**ADDITIONAL FINAL NOTICE**

**DATE:** January 20, 2022  
**TO:** Blue Bird Owners  
**Subject:** R20AY – Steering Wheel Nut Torque Confirmation

**IMPORTANT SAFETY RECALL NOTICE**

**SUBJECT:** R20AY – Steering Wheel Nut Torque Confirmation

Photo 1

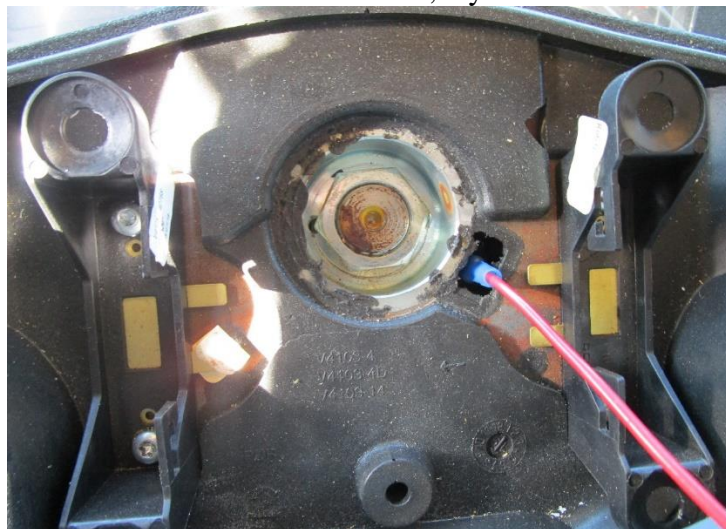
1. Lift up on top of steering wheel cover to remove. See Photo (1)

2. The cover contains the horn wire, lay the cover to the bottom.

3. Torque the steering wheel nut to 40-50ft lbs.
4. Ensure the horn wire is securely connected, then reinstall the steering wheel cover by pressing bottom portion in first followed by top of steering wheel cover until secure.
